XtremeAir GmbH, Harzstr.2, D-39444 Hecklingen Tel: +49 39267 60999 0, Fax: +49 39267 60999 20 www.xtremeair.de info@xtremeair.de	Document No. SB-2013-007
		Issue: A.01
DOA-Nr.: EASA.21J.360	Service Bulletin SB-2013-007	Date: 17.05.2013

Subject:	Tail wheel slide ring
Aircraft type affected:	XA41 & XA42
Serial numbers affected:	MSN 108 – 117 and 05 - 06
Compliance:	Optional
Time of Compliance:	At operator's discretion
Purpose:	To notify owners of an improvement to ease the rotation of the tail wheel fork.
Background:	The rotational friction of the tail wheel fork has been reduced by the installation of a slide ring. This present service bulletin describes the measure to install this slide ring.
Manpower:	It is estimated approximately thirty (30) minutes will be required to accomplish this bulletin.
Materials:	The following parts kit should be ordered through spares@xtremeair.de : <div style="margin-left: 40px;"> (1) ea. Slide Ring XA42-3260-225 A.01 (1) ea. Split pin 2,5x32 DIN94 </div>

Figure 1: Tail wheel lock assembly without slide ring

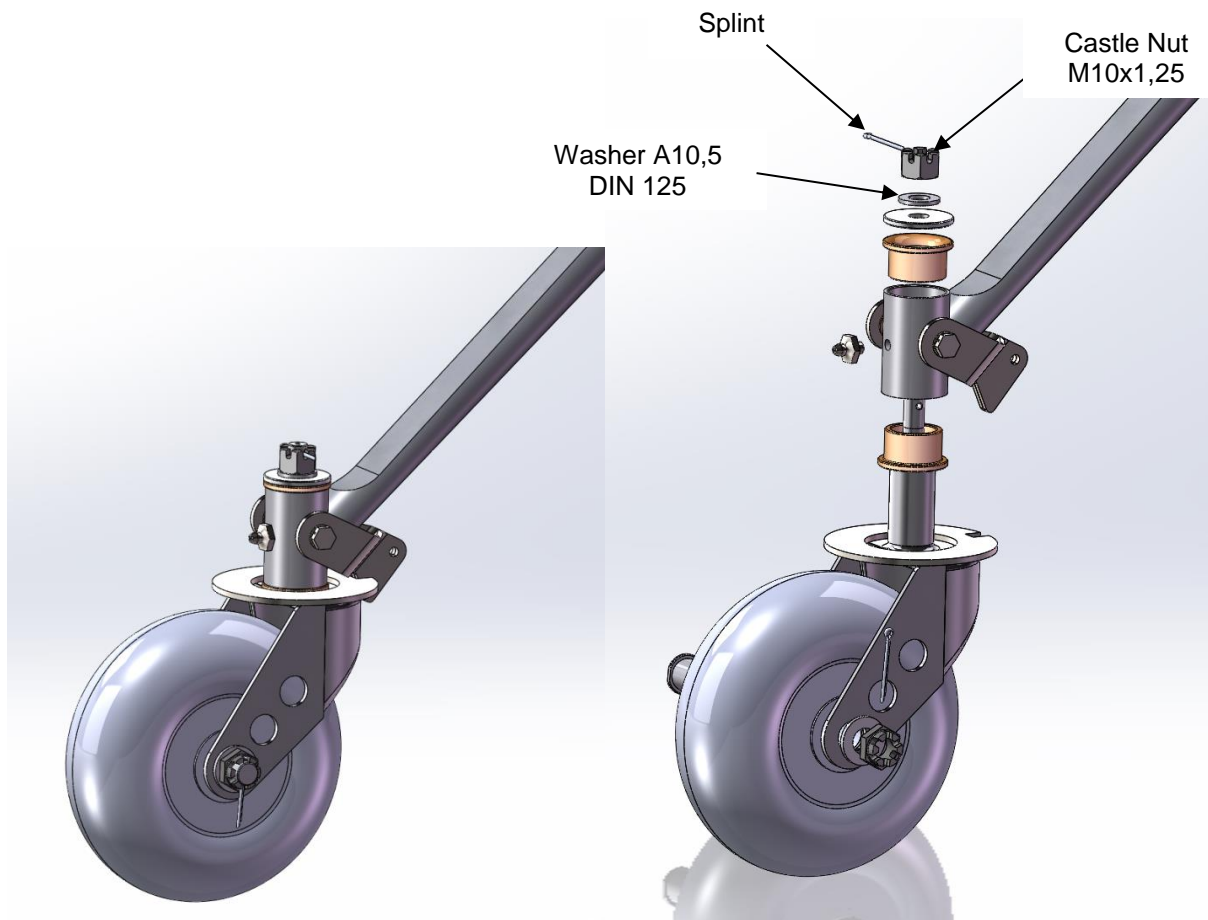
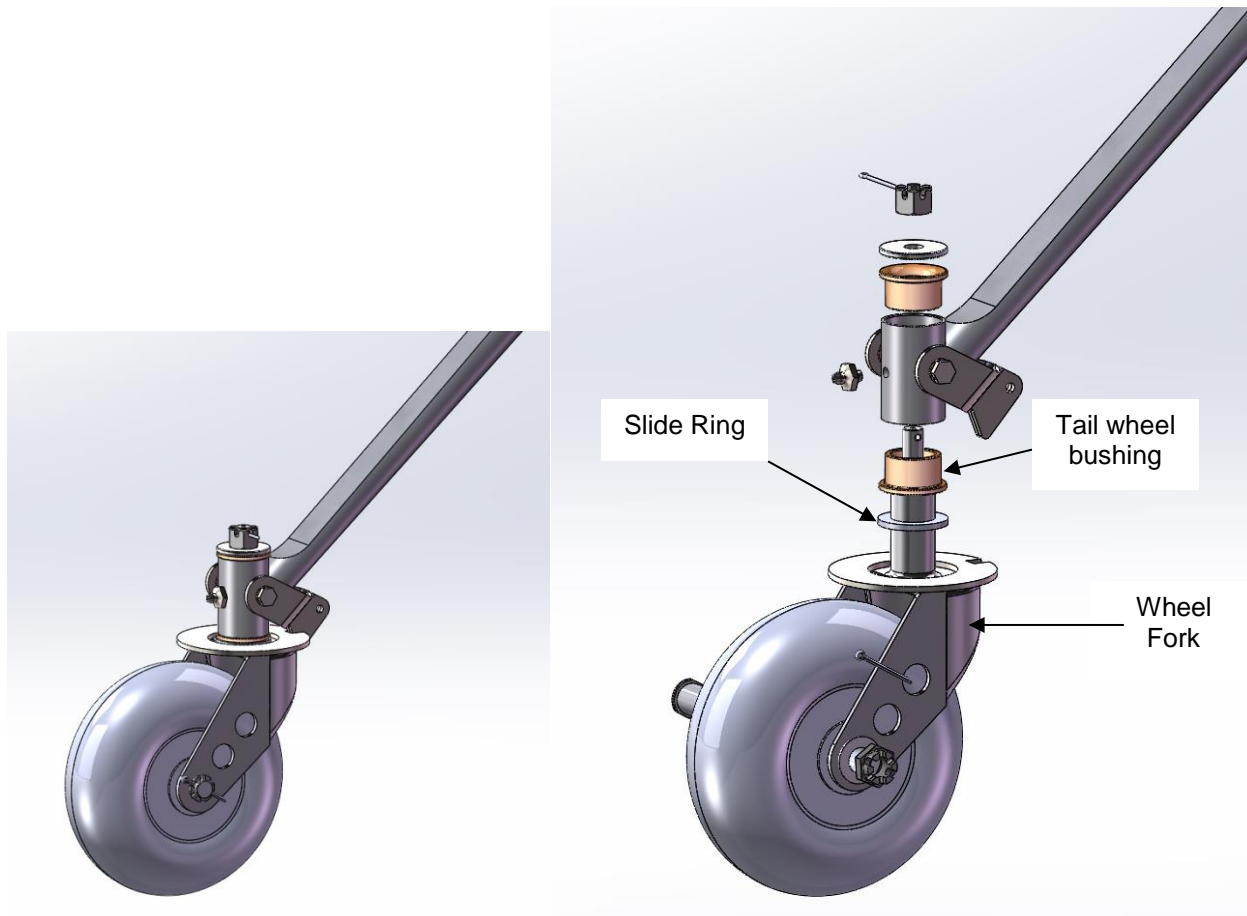
1. Shore the tail according to chapter 07-20-02 from the aircraft maintenance manual.
2. Remove the split pin. See Figure 1.
3. Unscrew the M10x1,25 castle nut
4. Disassemble the wheel fork and remove the A10.5 DIN125 washer (Figure 1).
5. Reassemble excluding the A10.5 DIN 125 washer and including the Slide Ring as shown in Figure 2.
ATTENTION!! Install the Slide Ring with the chamfered edge facing the bottom.
6. Fasten the castle nut and replace the split pin.
7. Carefully lower the tail from the support.
